SUBJECT: CALVERT CLIFFS NUCLEAR POWER PLANT, UNITS 1 AND 2 – ISSUANCE OF AMENDMENT NOS. 323 AND 301 TO CHANGE TO LOW LEVEL REFUELING WATER TANK (CAC NOS. MF9491 AND MF9492; EPID L-2017-LLA-0191)

SAFETY EVALUATION BY THE OFFICE OF NUCLEAR REACTOR REGULATION

AMENDMENT NO. 323 TO RENEWED FACILITY OPERATING LICENSE NO. DPR-53

AMENDMENT NO. 301 TO RENEWED FACILITY OPERATING LICENSE NO. DPR-69

Figure 1. Distance from Top of Outlet Pipes to the Bottom of the RWT

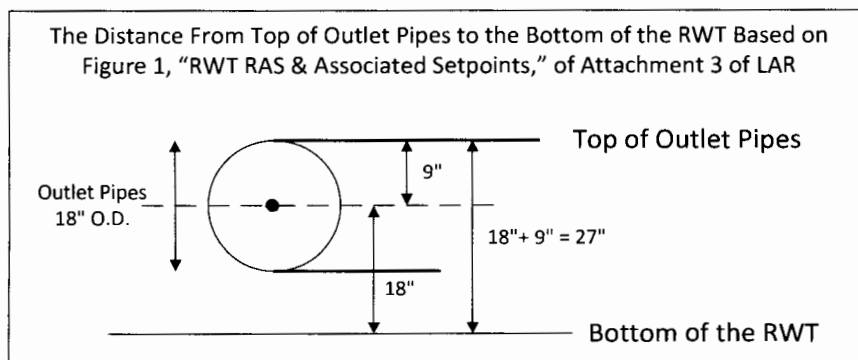
The NRC staff reviewed calculation CA10206, "RWT Level RAS Setpoint Determination," Attachment 3 of the LAR, to verify that the distance from the bottom of the RWT to the top of the outlet pipe is an appropriate setting for automatic protective action that will correct an abnormal situation before a safety limit is exceeded.

The current TS Table 3.3.4-1 RWT level-low AV of  $\geq 24$  inches is nonconservative, as shown in Figure 1 above. In order to minimize or eliminate air entraining in the ECCS during the injection phase following a LOCA, the licensee proposed to raise this parameter from greater than 24 inches to 42 inches. Consequently, the staff finds this proposed change to be acceptable, because the proposed RWT level is higher than the required water level to prevent vortexing.

Figure 2. NRC Staff Margin Calculation

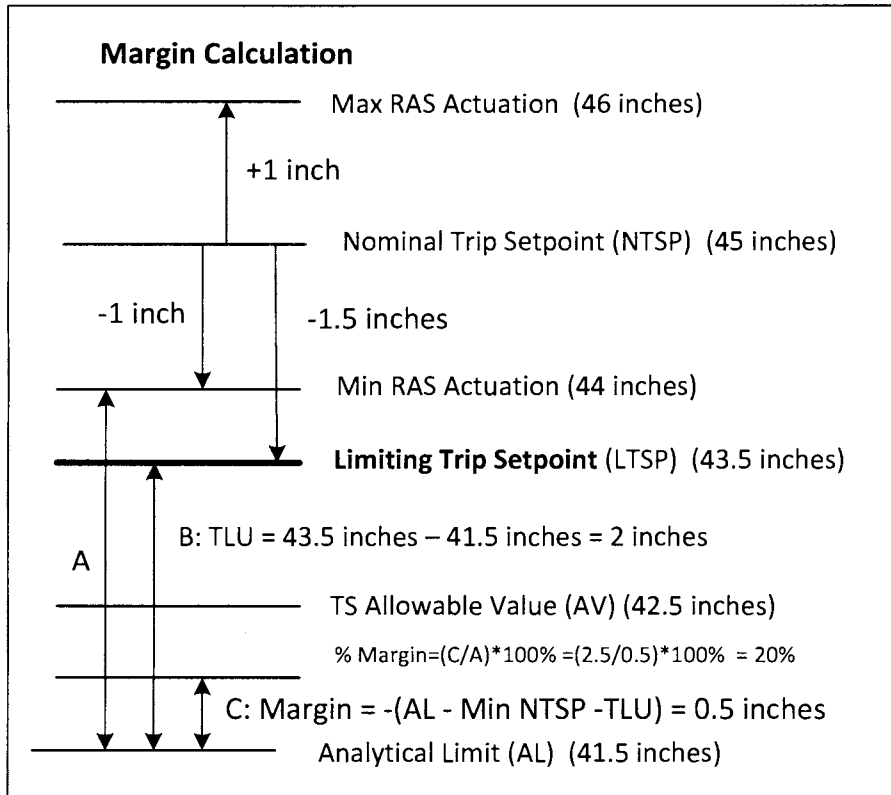
Based on RG 1.105, Revision 3, the NRC staff calculated the TLU as shown in Figure 2 below.

The NRC staff used RG 1.105, as shown in Figure 2 above, to independently calculate and verify the margin between the NTSP and associated AL for the worst-case minimum RAS actuation (which requires an as-found value of at least 44 inches).

- (3) The proposed AL will provide a sufficient margin (greater than or equal to 20 percent, as shown in the margin calculation above) that exists between the NTSP (as-found value) and the AL. This margin reflects the trip setpoint, which has been chosen to assure that a trip or safety actuation occurs before the process reaches the AL level to satisfy the 10 CFR 50.36(c)(1)(ii)(A) requirements. In addition, the RWT level switch function meets the performance criteria of RG 1.105.
